ADDENDUM NO. ONE (1)

REMARK AIRFIELD

**MEDINA MUNICIPAL AIRPORT
MEDINA, OHIO**

DELTA PROJECT NO. 19077

CRACK REPAIR DETAIL (TYPE B)
(> 3/4" WIDTH, ≤ 1" WIDTH)

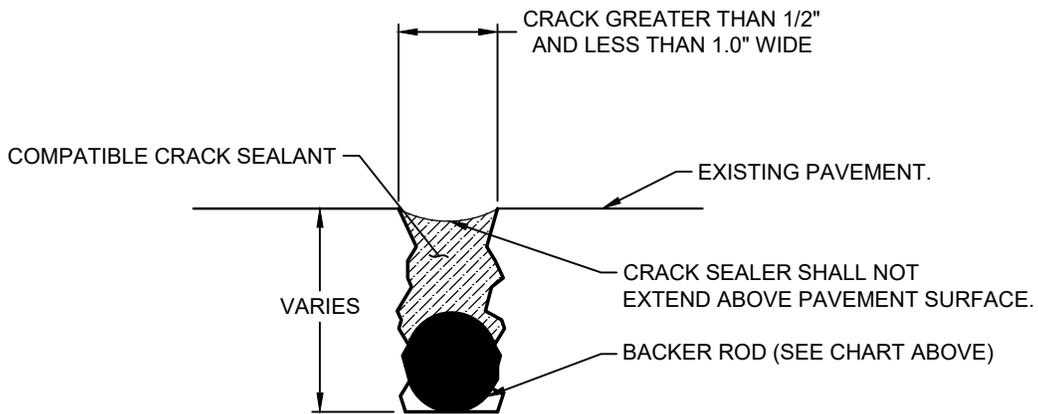
- 3.** **REPLACE** the “Crack Repair Detail (Type B) ($>3/4$ " Width, ≤ 1 " Width)” detail with the attached revised detail shown in Exhibit 7-1 of Addendum No. One (1).
- 4.** **ADD** the attached Crack Sealing Detail (Type B) ($>3/4$ " Width, ≤ 1 " Width)” detail shown in Exhibit 7-2 of Addendum No. One (1).

1. CRACK PREPARATION, ROUTING (IF REQUIRED) CRACK FILLER, ETC. INCLUDED WITH CRACK REPAIR (P-101).
2. REMOVE ANY VEGETATION, DIRT, DAMPNES, AND LOOSE MATERIAL FROM CRACKS. APPLY HERBICIDE BEFORE FILLING.
3. CRACK FILLER SHALL COMPLY WITH ASTM D6690, TYPE III AND SHALL BE CRAFCO ROADSAYER 222, W.R MEADOWS SEALTIGHT 3405, P&T PRODUCTS DURA-FILL 3405, OR EQUIVALENT APPROVED BY THE ENGINEER.

CRACK WIDTH (W)	CLEAN-OUT DEPTH	SEALANT DEPTH (H)	BACKER ROD DIA.
3/4"	1-5/8"	1-1/2"	15/16"
1.0"	2-1/4"	2.0"	1-1/4"
